Client
MICHAEL O'SHAUGHNESSY CONSTRUCTION
Owner
SAN FRANCISCO PUBLIC WORKS
Project
SFPW 1000015860 PAUL AVE, WOOLSEY ST
AND SALINAS AVE PAVEMENT RENOVATION
AND SEWER REPLACEMENT

Sheet Title
TEMPORARY TRAFFIC CONTROL PLAN FOR
SEWER MAIN INSTALLATION ON PAUL AVE,
WOOSLEY ST, AND SALINAS AVE - SHEET 5
OF 15

Sheet
TCP-005

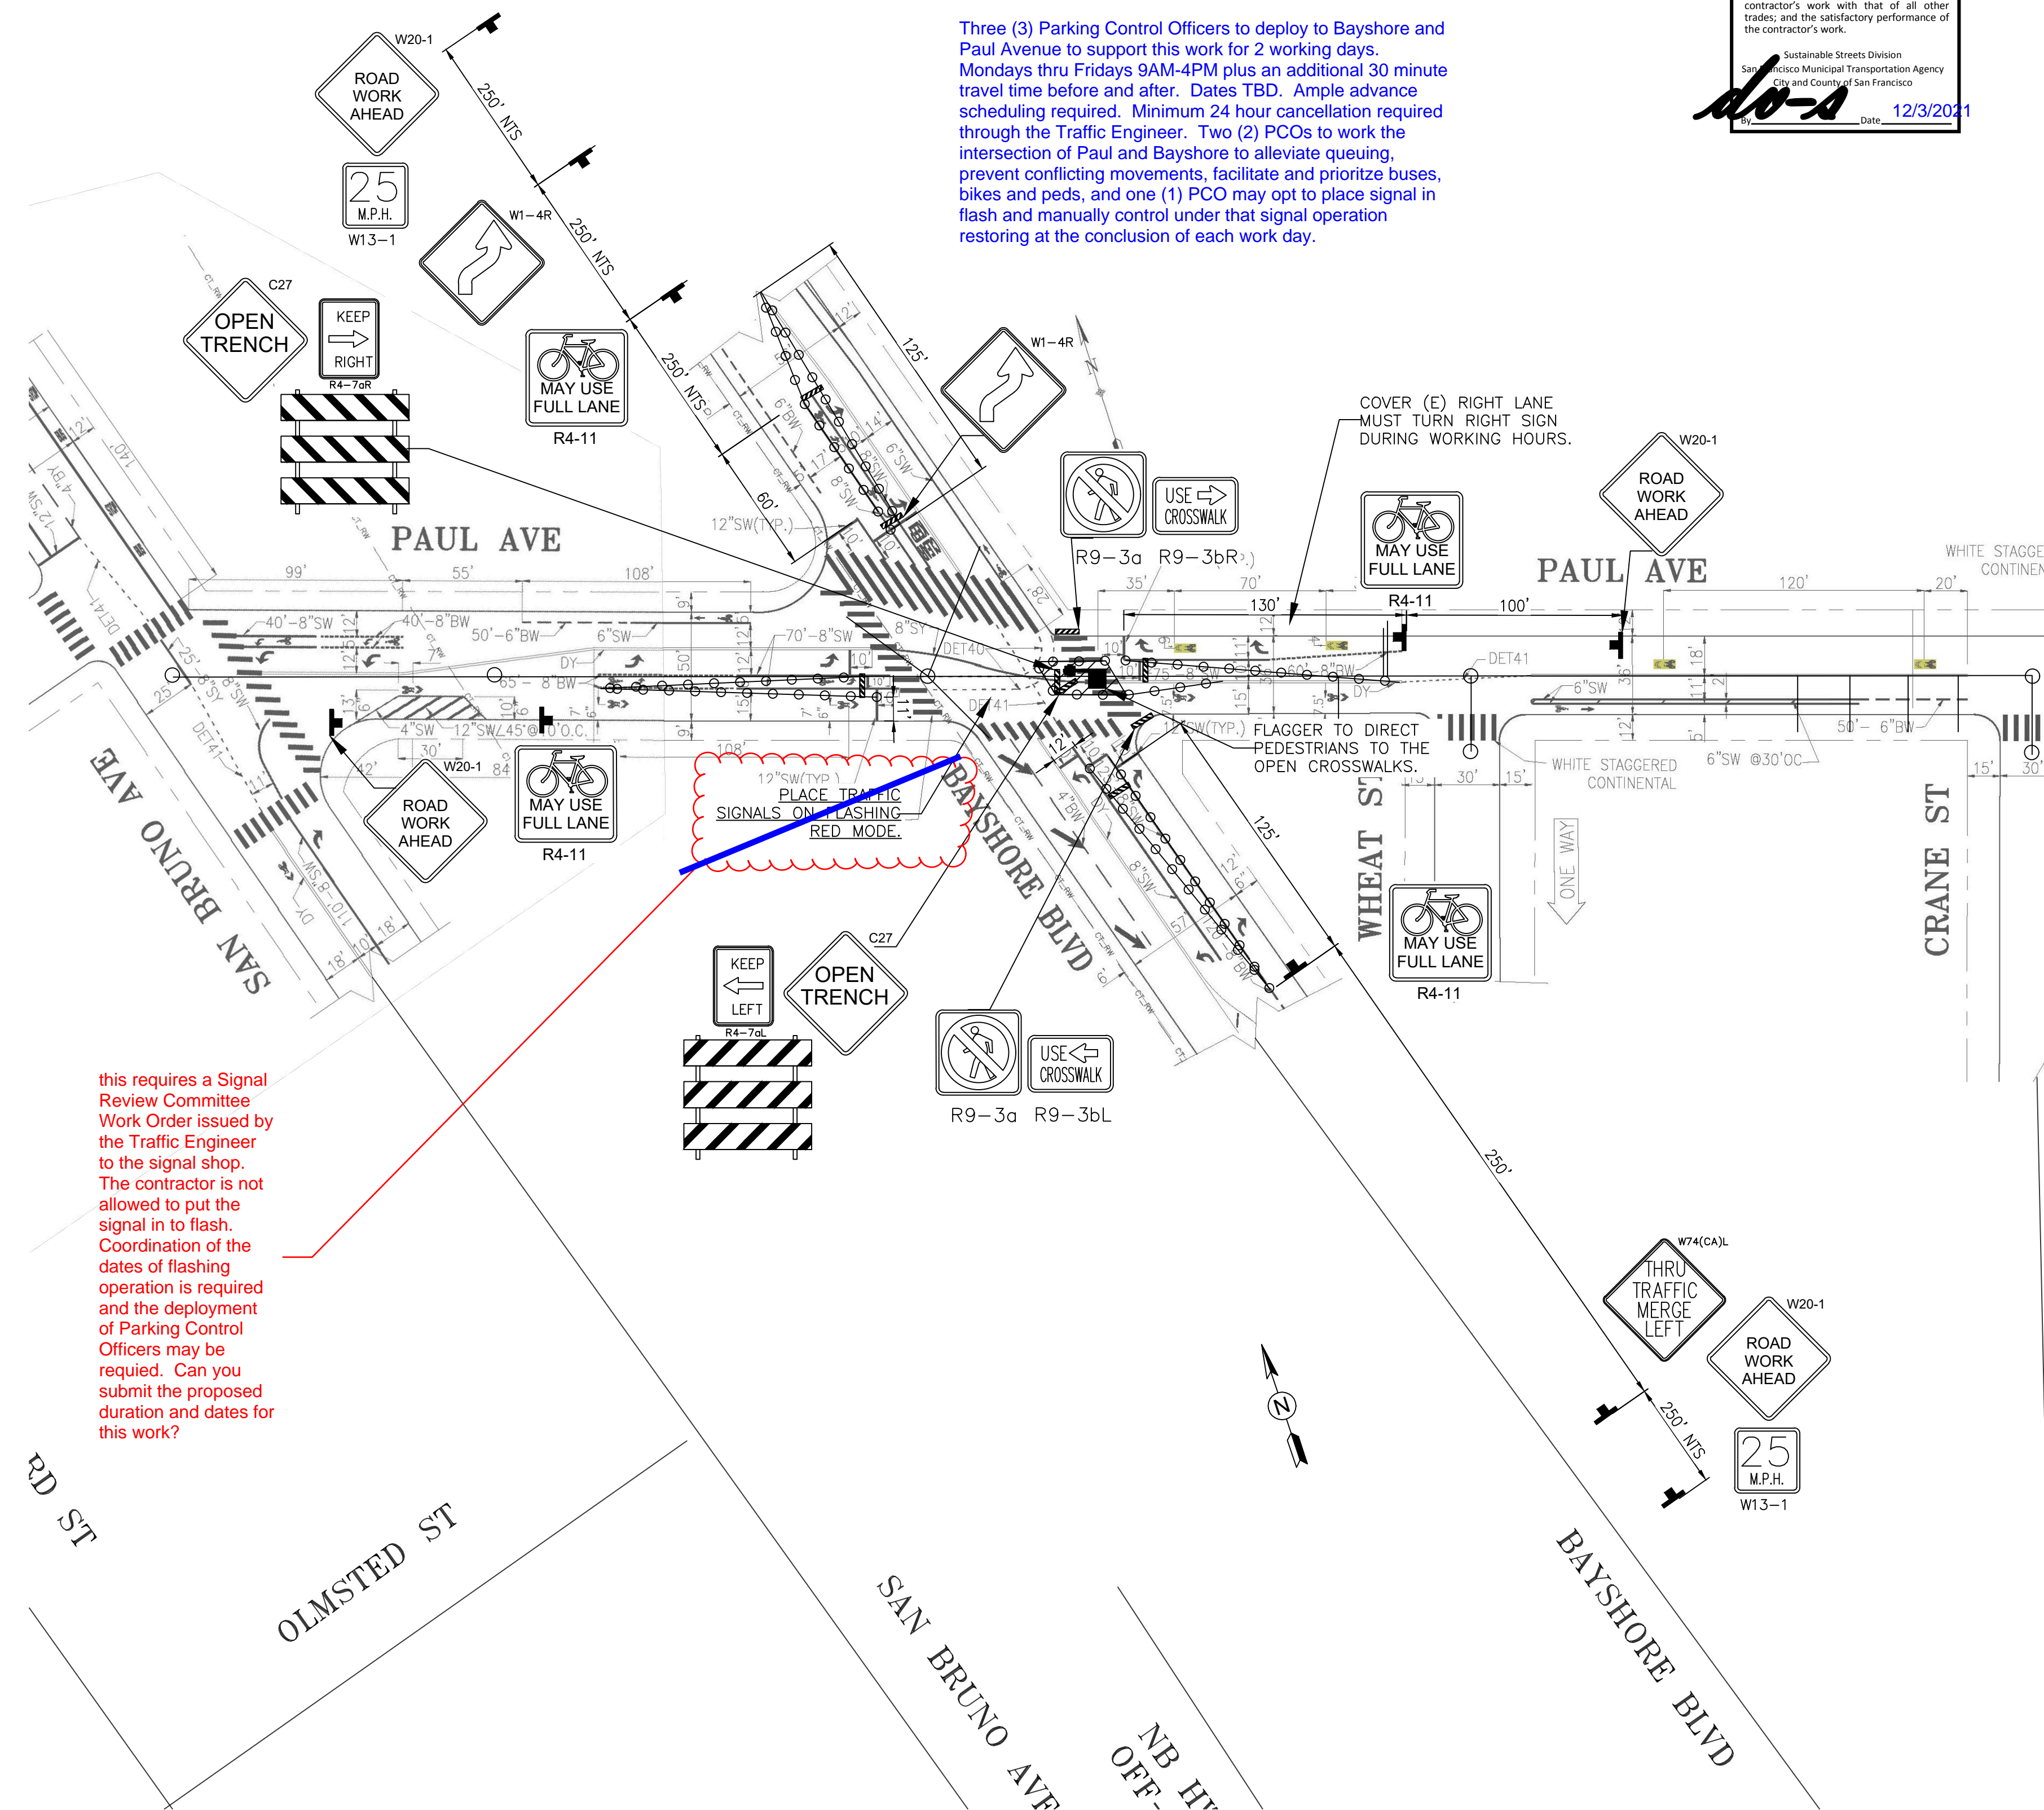
this requires a Signal Review Committee Work Order issued by the Traffic Engineer to the signal shop. The contractor is not allowed to put the signal in to flash. Coordination of the dates of flashing operation is required and the deployment of Parking Control Officers may be required. Can you submit the proposed duration and dates for this work?
